Council Reference: A006721031
Attention: Shirley Mills

RE: Minor Change to a Development Application – Multiple Dwelling (192 Units) and Food and Drink Outlet at 299 Coronation Drive, Milton QLD 4064

Figure 2: Extract of Building Outline Demonstration Plan (Source: Plus Studio)

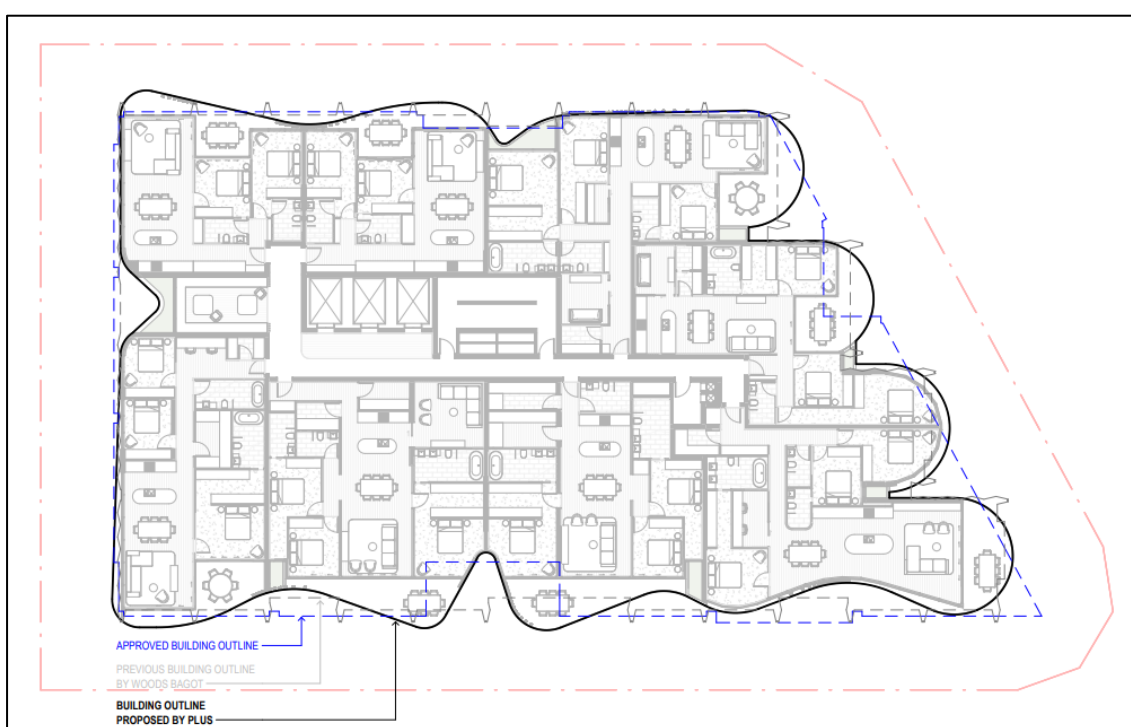
The changed proposal further provides opportunities to reconsider building siting and in doing so increases building setbacks to the adjoining commercial office building fronting Coronation Drive, with a minimum 5 metre setback now provided to residential unit levels. Building setbacks to the balance of property boundaries are not materially changed, noting there are however minor elements that push toward boundaries and pull in from boundaries as compared to the previous proposal. Proposed boundary setback changes assist in providing improved building articulation and visual interest to the façade. Careful consideration as been given to the orientations of units and the areas in which minor changes in setback are proposed, to ensure any potential for external impacts is appropriately managed and mitigated.

Overall, the proposed changes/treatment of the facades will provide considerable improvements to the articulation, modulation and visual amenity of the building whilst ensuring that the extent of the building outline remains relatively consistent with both the approved office tower over the site, as well as the building outline proposed through the previous minor change to the pending development application. As can be seen from the Building Outline Demonstration Plan, prepared by Plus Studio and to which an extract can be seen in Figure 2 below.
